OptiBean NG OptiBean Touch Model 2016 Model 2017

Reversed brewer

Modifications

Updated September 2019

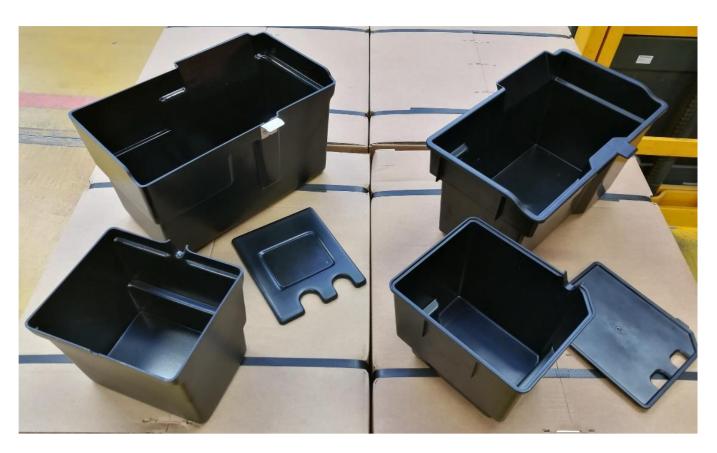
Coffee waste- & Water waste bin	
Part	Coffee waste bin / Water waste bin + lid
Solves problem	-
Modification	Heavy duty plastic (injection mold)
From mach. no.	Mach.no. 1NB10502 - Week 14/2018
Retrofit	New bins fit in: OptiBean (model 2011), OptiBean NG (model 2015), OptiBean Touch (model 2017) (Attention: New bins does not match Old bins)
Article number	1006405 Coffee waste bin 1006406 Water waste bin 1006407 Lid for water waste bin
Action	no

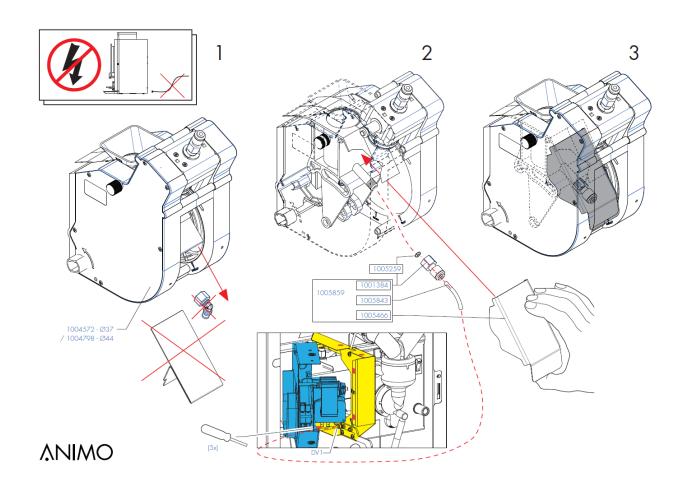
Brewer reversed	
Part	stainless steel cover
Solves problem	easy cleaning- and access to brewer water inlet coupling
Modification	new removable stainless steel cover (standard in each machine and brewer spare part)
From mach. no.	3Zxxxxx (production July 2016)
Article number	1005859
Retrofit	Yes
Action	no

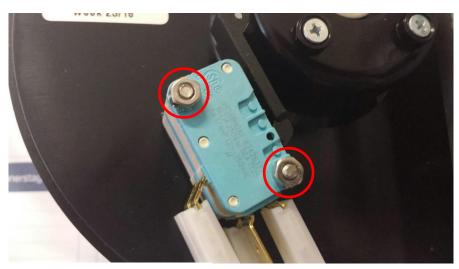
Brewer motor [1004573]	
Part	brewer switches
Solves problem	undefined E5/E24 errors
Modification	Improved brewer switch fixation
From mach. no.	3Zxxxxx (production July 2016) / from wk 23/2016 brewer motor sticker
Article number	1004573
Retrofit	no, only by changing the complete brewer motor
Action	no

Previous brewer switch fixation

New brewer switch fixation
